2.12 Station Electrical Systems

The information in this section of the reference ABWR DCD, including all subsections, figures and tables, is incorporated by reference with the following departures.

STD DEP T1 2.12-2 (Figure 2.12.15)

Figure 2.12.15 Instrument and Control Power Supply

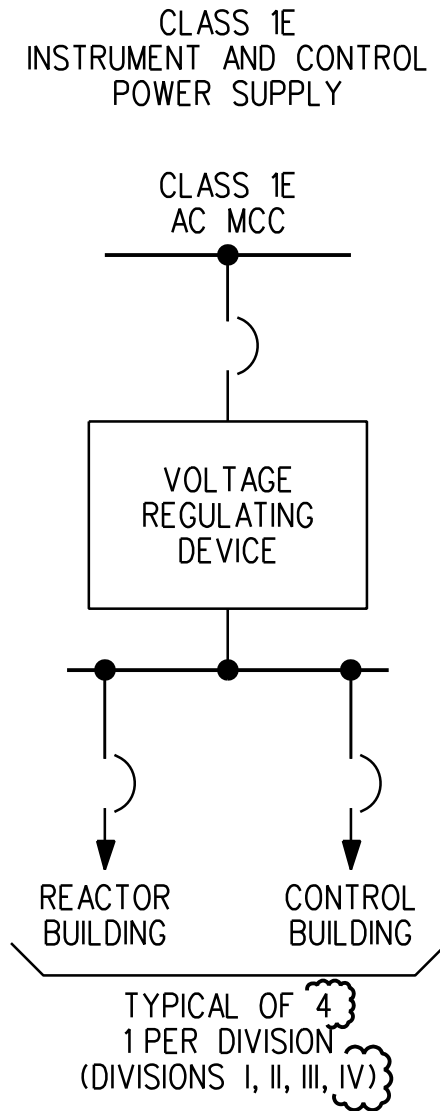
STD DEP T1 2.12-2

The Class 1E Instrument and Control Power Supply consists of ~~three~~ four divisions (Division I, II, ~~and III, and IV~~) of interruptible power supplies with their respective distribution panels. Each Class 1E power supply provides interruptible, regulated AC power to Class 1E circuits which do not require continuity of power during a loss of preferred power (LOPP).
